Report to the Future Melbourne (Planning) Committee

Planning Permit Application: TP-2019-665
131-133 Domain Road, South Yarra

8 December 2020

Figure 10 – Artistic Impression of Proposed Development (image shows a red line indicating the reduction in height as amended application dated 18 September 2020).

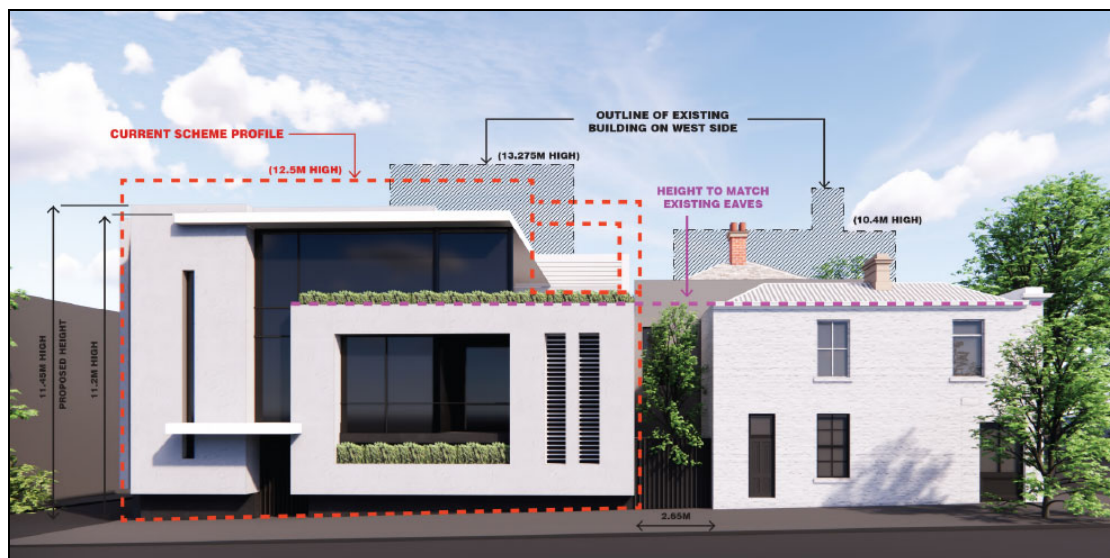
- Reduction in overall building height.
- Design modifications relating to the transition between the existing retained building and proposed addition.
- Deletion of the pool projecting over the footpath.
- Increase activation and engagement with the public realm.
- Splaying the south-east corner to improve sightlines and safety.

Figure 16 – Previously proposed addition

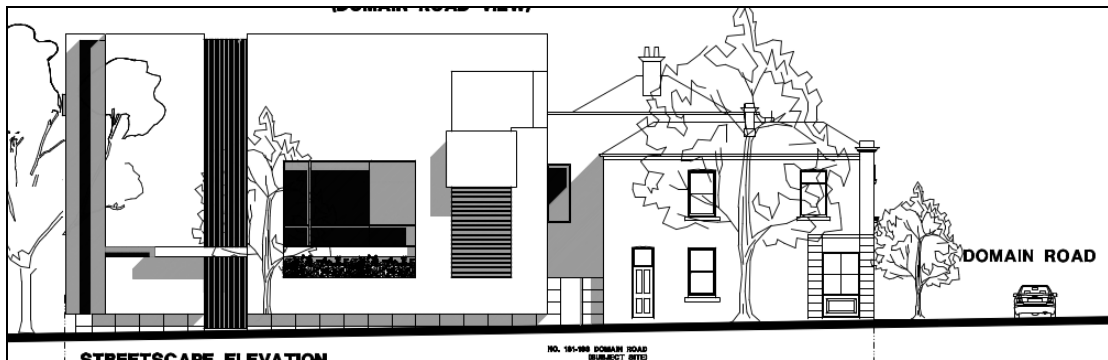
It should be noted that the above heritage comments related to proposal prior to the application being amended to reduce the height of the addition (Figure 16). The latest development plans have made significant improvements that provide a more considered design response relating to the existing heritage buildings.

Figure 18 - Proposed Millswyn Street elevation

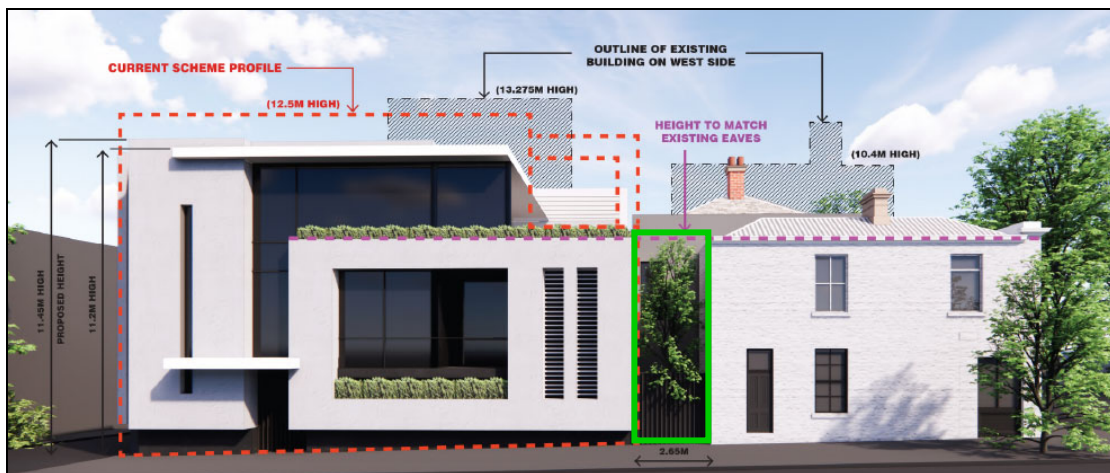
- The Millswyn Street elevation contains blank walls and a planter that is too high and not of a pedestrian scale.
- The legibility of entry and sense of address remains unaddressed in the discussion drawings.

- The large concrete façade planes to the Millswyn Street frontage cantilever above ground, resulting in an ill-defined space at street level which will be a litter trap, and erodes street definition.

Since the above advice was prepared, the applicant addressed many of the issues raised by formally amending the development drawings on 18 September 2020 (57A Amendment). The changes included reducing the building height, adjusting the Millswyn Street elevation to include more refined detail and deleting the projecting pool.
